Memorandum

Date: 9 April 2009
To: Mary Anne Skorpanich, Director, OC Watersheds Program
cc: Jeff Pratt, Public Works Director, County of Ventura
From: Eric Strecker, P.E. and Aaron Poresky, E.I.T. Geosyntec Consultants
Malcolm Walker, P.E. Larry Walker and Associates
Subject: Response to Critical Comments on "Low Impact Development Metrics
in Stormwater Permitting"

This document contains Geosyntec response to elements of "Critique of Certain Elements of 'Low Impact Development Metrics in Stormwater Permitting'" (Dr. Richard Horner, February 2009 (paper not dated))

Figure 1: Comparison of precipitation and ET patterns between western Texas and southern California

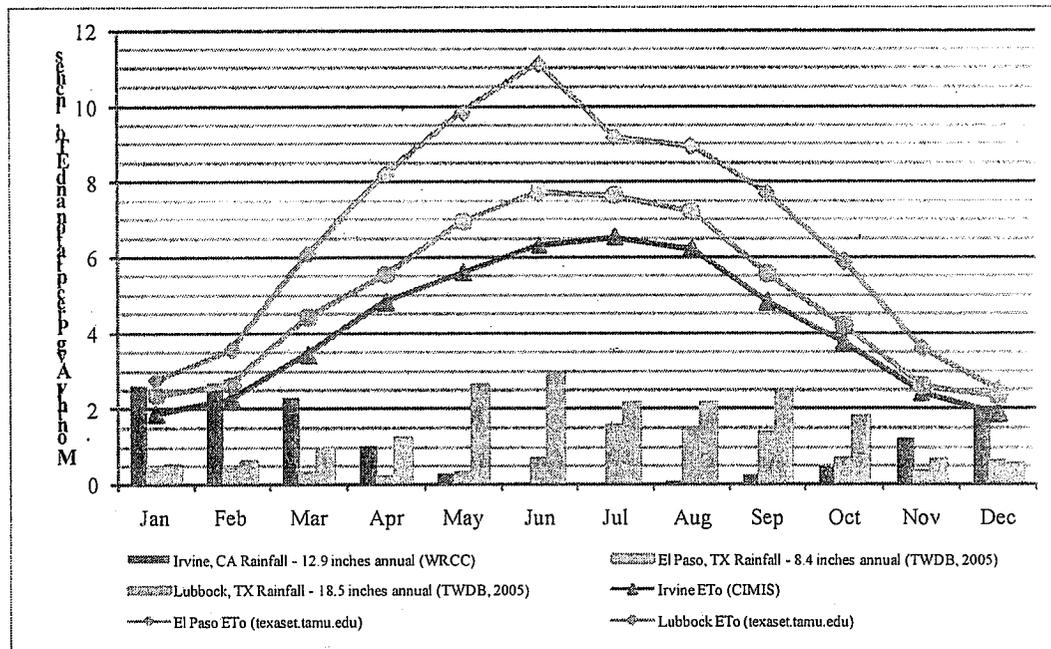
The critique refers to an established program of rainwater harvesting and reuse in Texas. While eastern Texas receives greater rainfall than Southern California, the critique states that western Texas “has rainfall conditions very much like southern California’s”. A detailed review of the Texas Rainwater Harvesting Guidelines (TWDB, 2005) showed that this program is primarily targeted toward using harvesting to meet water demands, not to control stormwater. It should also be noted that large parts of Texas receive summer rainfall in the form of thunderstorms which rarely, if ever, occur during the summer in Southern California. Figure 1 provides a summary comparison between precipitation and evapotranspiration patterns in western Texas versus southern California.

Based on this preliminary comparison, western Texas appears to be a more favorable location than southern California for rainwater harvesting to manage stormwater impacts and meeting water demands. First, periods of higher rainfall are coincident with periods of higher ETo in west Texas, while the opposite is true in southern California. Second,

rainfall occurs more steadily throughout the year in west Texas compared to the normally dry spring, summer and fall months of southern California.

Figure 2: Monthly normal patterns of ET and precipitation at Reagan National Airport

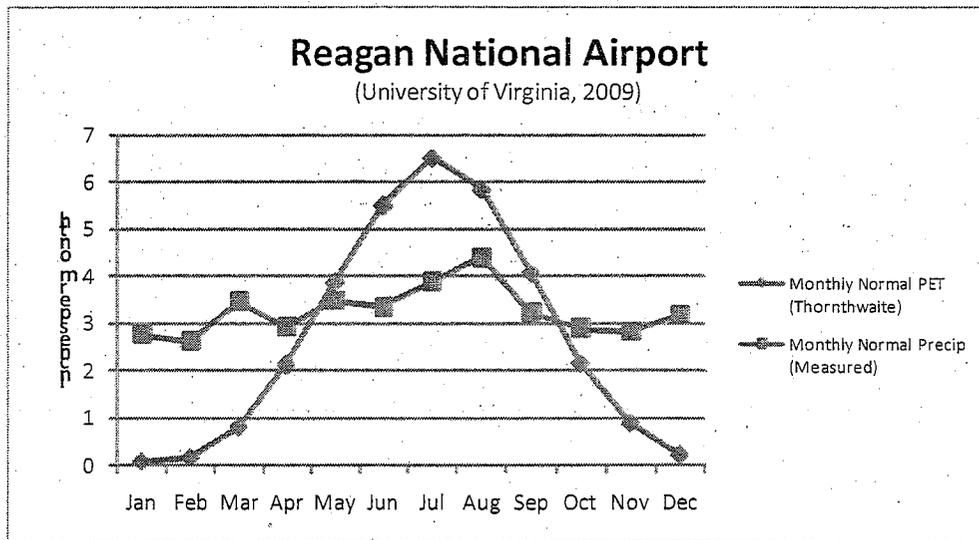
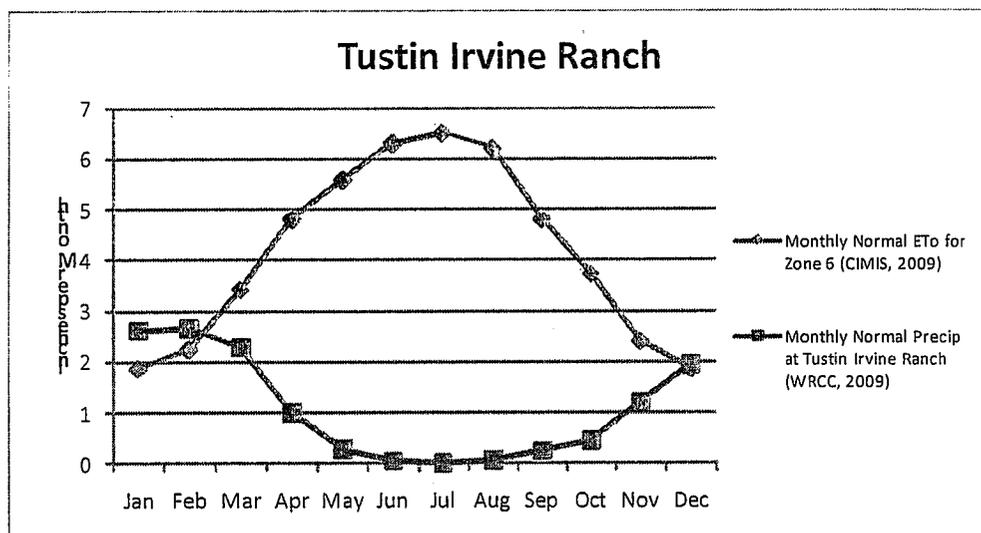
3.8 60 California – anticipated performance of greenroofs and cisterns. The critique provides a somewhat vague defense for the performance of greenroofs in Southern California. One cited study found that a greenroof in Pennsylvania could reduce average annual runoff volumes by 50 percent. This study was compared to Southern California by saying that pan evaporation rates are between 3.3 and 4.2 inches per month in Pennsylvania from June to September (presumably a wet season in that locale) while November – February pan evaporation ranges from 3.5 to 4.0 in Los Angeles. A review of local ET data in Los Angeles County showed that this comparison is not valid. Monthly ET rates in Southern California range from about 1.5 to 2.5 from November through February. Also, rainfall is more seasonally concentrated in Southern California than in the mid-Atlantic region. Figures 2 and 3 below provide a comparison between Irvine, CA and the Washington, DC vicinity, for example.

Dr. Horner states: “Therefore, Los Angeles has as much evaporation potential in the months when it most needs that potential as locations with successful green roofs elsewhere.” Figure 2 shows that ET rates in December, January, and February are lower than the average precipitation. As precipitation is rarely average, on frequent occasions rainfall rates will significantly exceed ET rates. Thus Dr. Horner’s conclusion does not seem to be supported by the examples provided.
